Access Compliance Report Public Rights-of-Way (Curb Ramps)

Main Street: ANTONIO_PKWY Cross Street: N/A Location: E

ADA ID: RPRK211122114131 Ramp Type: Type 1 - Perpendicular Diagonal Initial Pass/Fail: Pass Overall Compliance: No Severity Score: 17

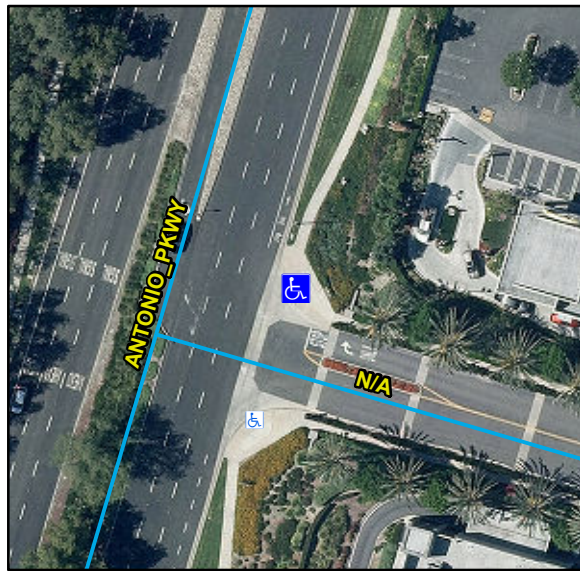
Possible Solutions:

Remove & Replace Curb Ramp With Two New Directional Ramps or Equivalent.

R304.2.2, R304.2.1, R304.2.2-Perp, R304.3.2-Para, R304.2.3, R305, STD 1115
